# **Awel y Môr Offshore Wind Farm**

### **Volume 4, Annex 3.1: Water Framework Directive Compliance Assessment**

#### **Deadline 8**

Document Reference: 8.52

FIGURE NUMBER:  
**Figure 8**

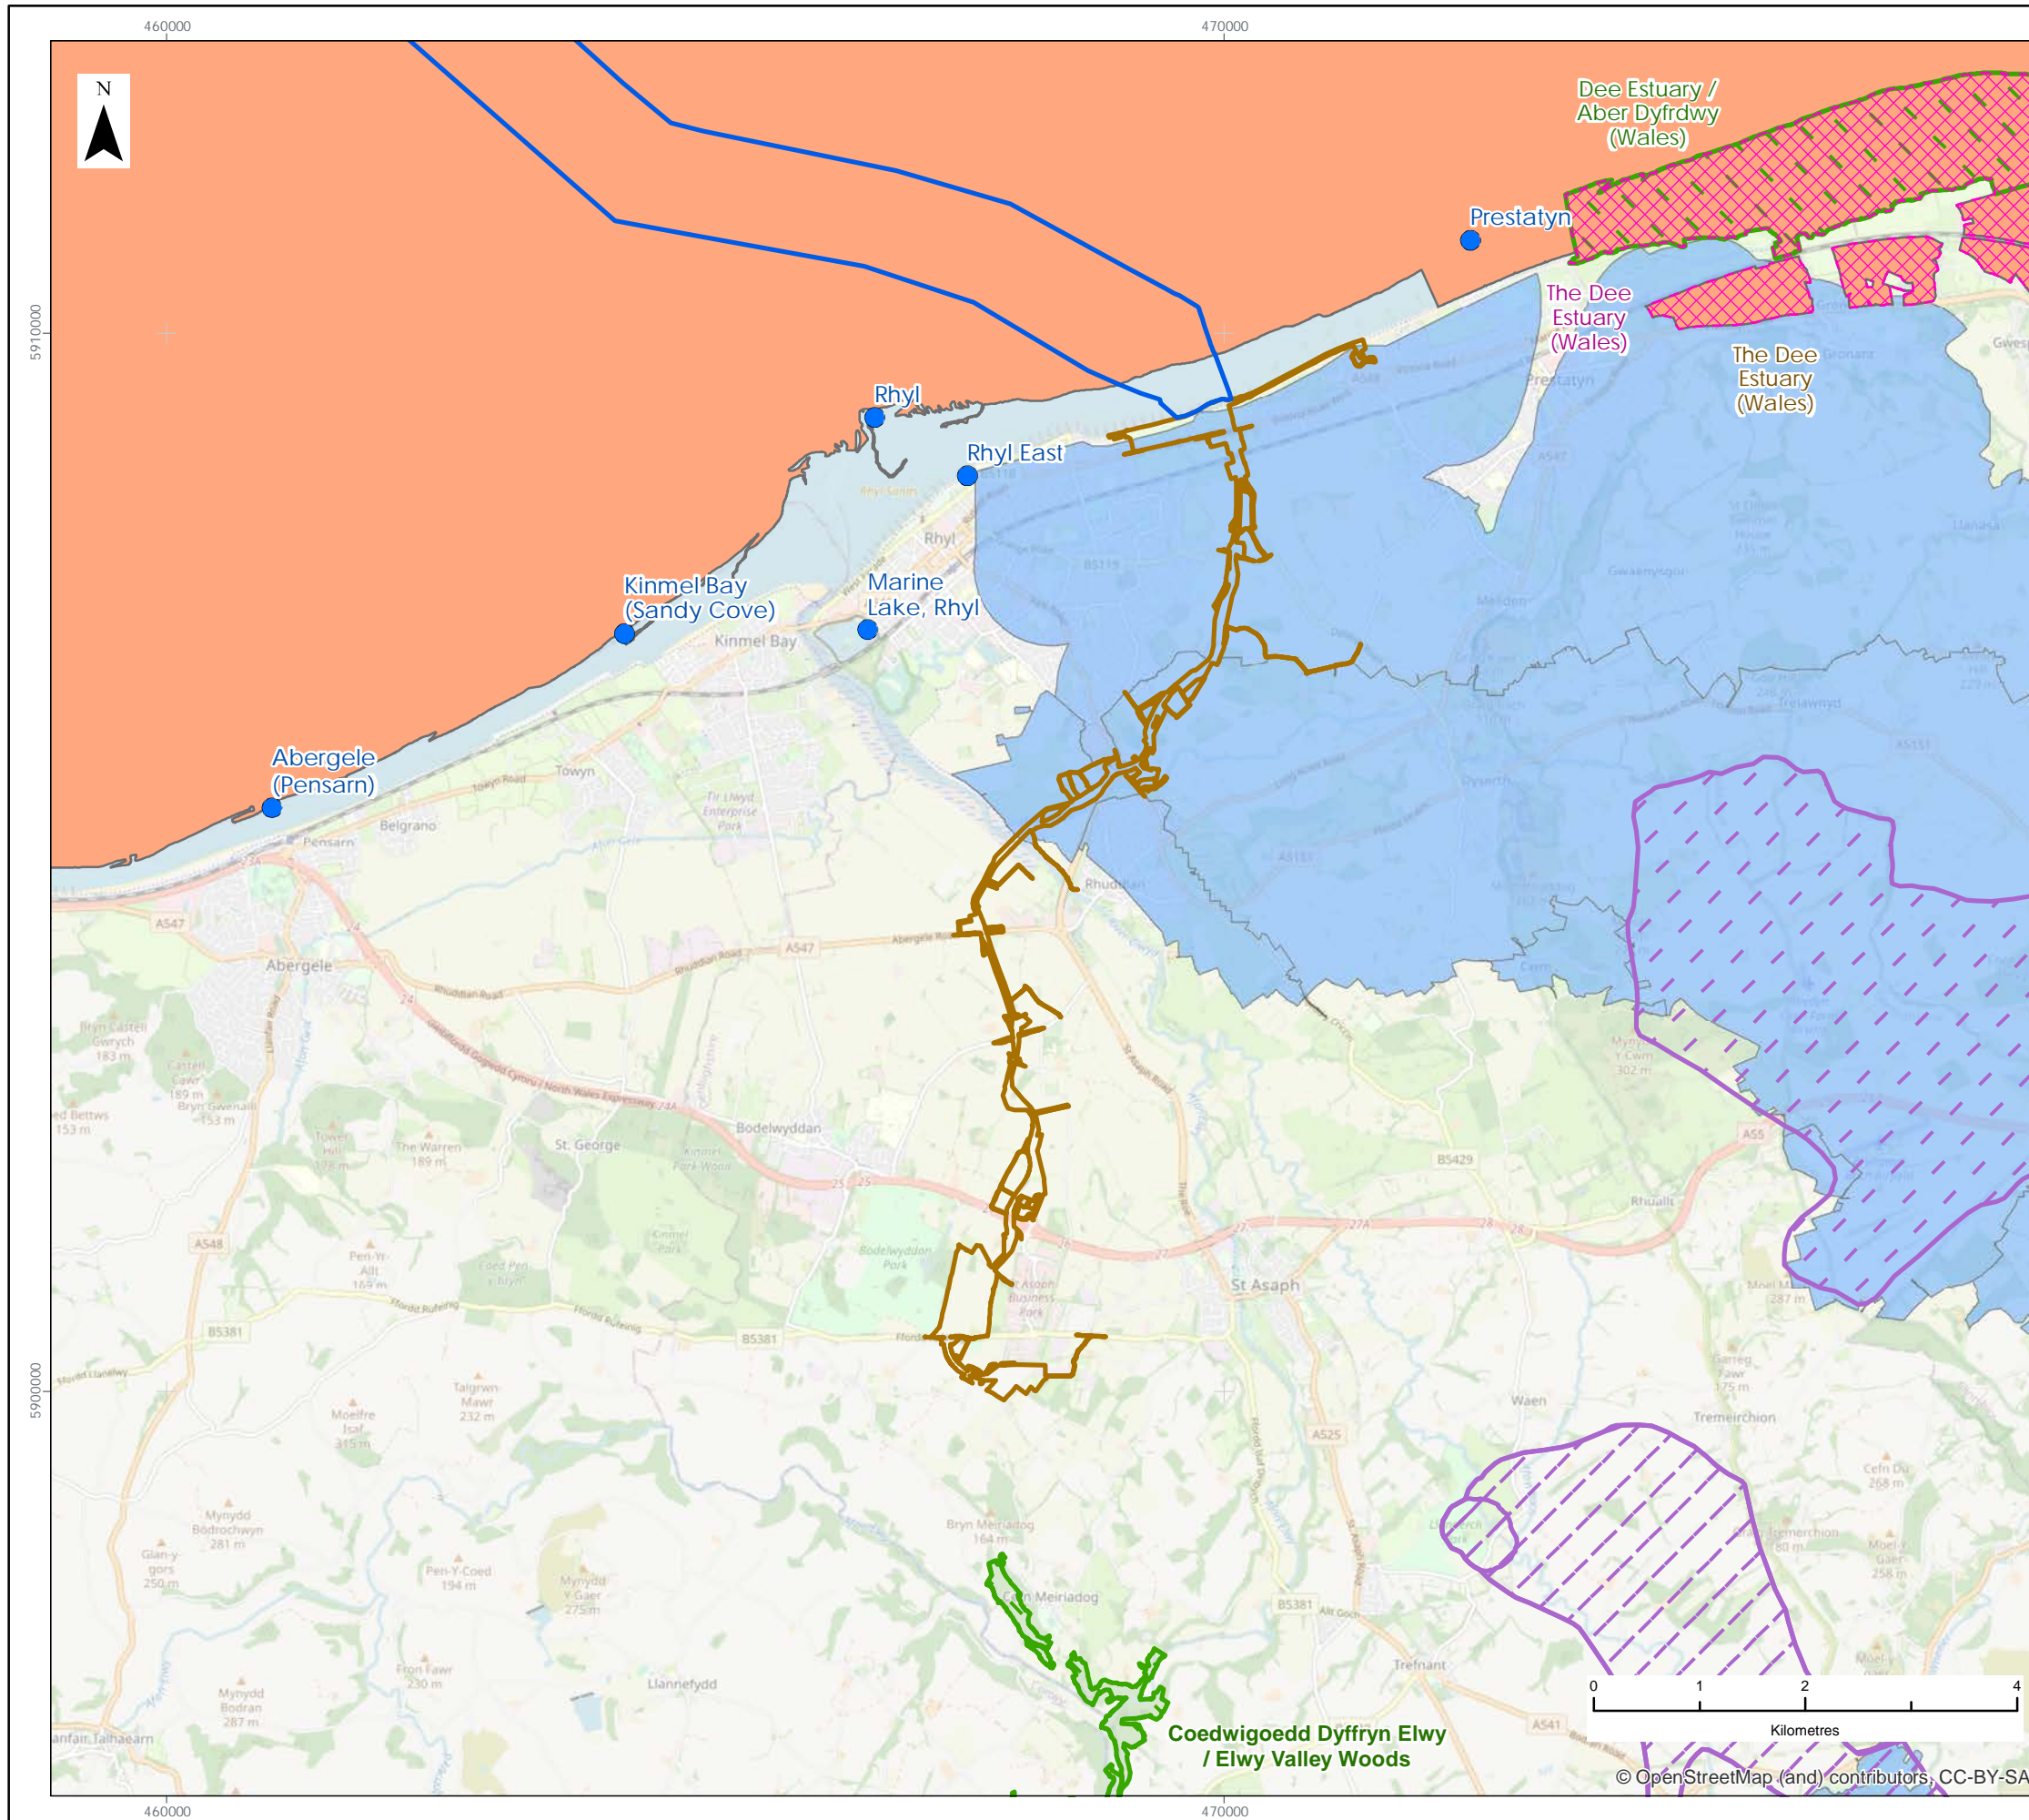
PEIR Section 42 Response (NRW, October 2021)	Section 5.7 Protected areas screening – The Dee Estuary SAC also falls within the North Wales coastal waterbody as highlighted in Figure 8. The site will need to be screened in to the assessment as there is the potential for changes in suspended sediment concentration to impact the "mudflat and sandflats not covered by seawater at low tide" feature of the Dee Estuary SAC (Volume 2, Chapter 2 Marine Geology, Oceanography and Physical Processes and Volume 2, Chapter 5: Benthic Subtidal and Intertidal Ecology).	The Dee Estuary/ Aber Dyfrdwy SAC has been included as part of consideration of WFD protected areas, with reference made to the conclusions of Report 5.2: RIAA (application ref: 5.2).
